AMENDMENT TO
LAREDO SPRINGS
PRELIMINARY OVERALL DEVELOPMENT PLAN
THIS POADP AMENDS PLAN #427-E PREVIOUSLY APPROVED BY THE PLANNING DIRECTOR ON 7/9/99

LAREDO SPRINGS (AMENDING) #427-E

PRELIMINARY OVERALL DEVELOPMENT PLAN

Re: Laredo Springs Subdivision

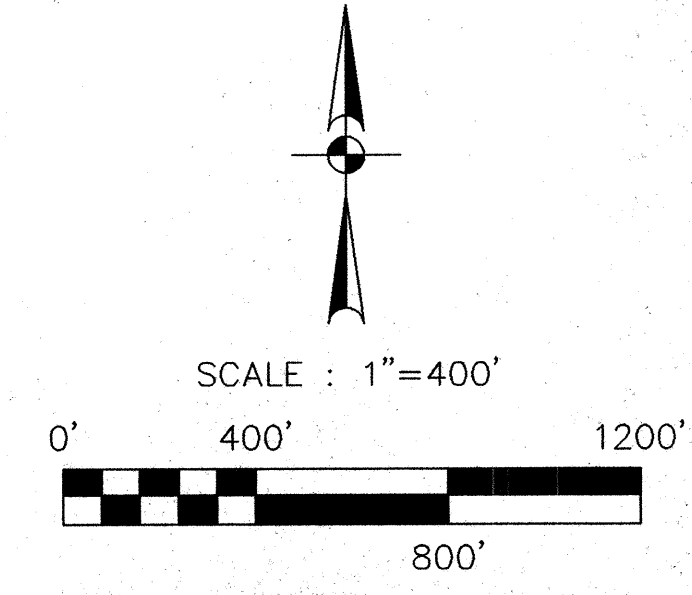
- REASONS FOR THIS AMENDMENT:**
1. Upgrade the street and lot layout of Unit II through Unit VIII.
 2. Relocate the Recreation Center area.
 3. Increase the commercial area along the south right-of-way of the proposed Wilderness Oaks.
 4. Relocate the third entrance road farther west.
 5. Provide topographic lines that were omitted on the previous plan.
 6. Update the plan with recording info for property within and adjoining the limits of the overall development plan.
- DEVELOPER:** 281 CANYON PARTNERS, LTD.
1600 N. COLLINS BLVD., STE. 2100
RICHARDSON, TEXAS 75080
- TOTAL AREA = 522.6 Ac.
874 SINGLE FAMILY
3 COMMERCIAL / MULTI-FAMILY TRACTS
1 RECREATION CENTER
